# Belvac Production Machinery Technical Bulletin

ISSUE 07 VOL. 4 OCTOBER 2001

## LUBRIQUIP INJECTOR UPGRADE

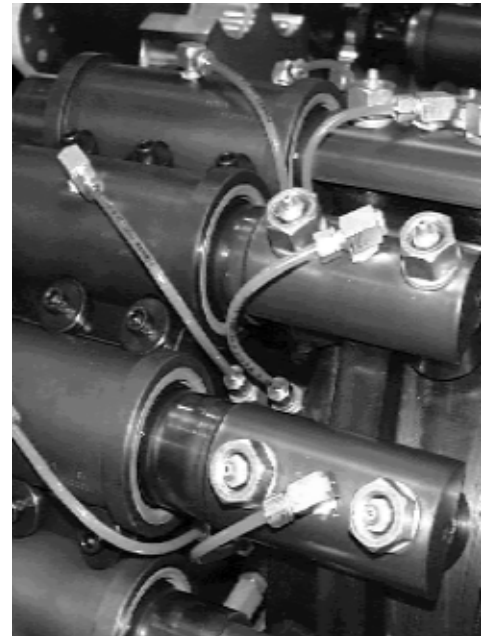
Belvac has introduced an injector upgrade for all 595K, fixed base and modular machines, directly replacing the SL33 Lincoln Injectors. The upgrade affords ease of maintenance allowing future injector replacement without disassembly of turret components.

Each kit comes complete with grease tubes, elbow adapter with indicator, and injector, metered and preset for the specific application. The injectors in these kits have been factory set to meter the correct amount of grease for that specific application.

This design offers the same functionality, and installation, with the following attributes:

- .. Installs to existing turrets without turret disassembly
- .. Indicator is mounted on ram/bushing in plain view
- .. Requires no turret modifications
- .. Replaces individually as needed

***P/N 2752187:*** CAM FOLLOWERS INJECTOR KIT

***P/N 2752188:*** RAM BUSHINGS INJECTOR KIT

This feature will be standard on all new Belvac 595K modular machinery effective January 2002.
